File Ref: Plan Change 41 and 41A

Date: 23rd September 2019

Subject: Plan Change 41A Landscape & Visual Effects Technical Review Addendum V1.0

Figure 1 - Diagram showing indicative distances of landscape buffer zones

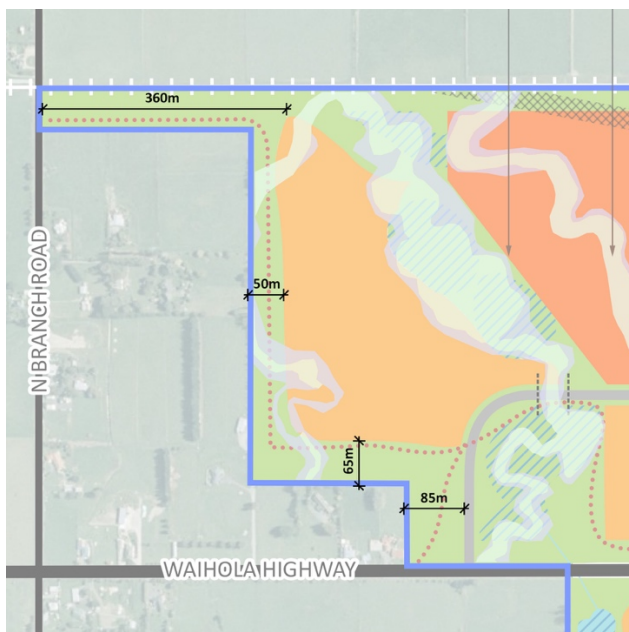
A number of submissions sought provision of a buffer zone and/or screening between the Industrial Zone and Milburn Settlement Zone. The requirement from this was identified as being due to incompatibility of industrial activity with existing residential activity, amenity and visual adverse effects.

The Structure Plan for 41A currently provides for a landscape buffer zone along the boundary between the Milburn Settlement Zone in the south-west. This includes areas of a minimum of 50m in width of land anticipated to incorporate both earth mounding and vegetation to provide visual disruption to and a green buffer strip to the adjacent industrial activities. Indicative distances based off the Structure Plan diagram are shown below.

It is considered that the provision of these landscape strips will be of sufficient width to provide for relatively significant earth mounding and vegetative screening. The earth mounding (up to 4m in height) will allow for vegetative screening to achieve more effective screening in a shorter timeline. Although earth mounding is included in the design guidelines put forward for Plan Change 41A it was not specified as a requirement. Given the reliance on earth mounding as an

integrated part of creating a buffer and mitigation visually for the proposed industrial built forms and activity, it is considered appropriate to include consideration for this within the design guide.

It is not anticipated that any increase in the width of landscape strips in these locations will have any increased or improved visual screening effect beyond what is currently proposed.
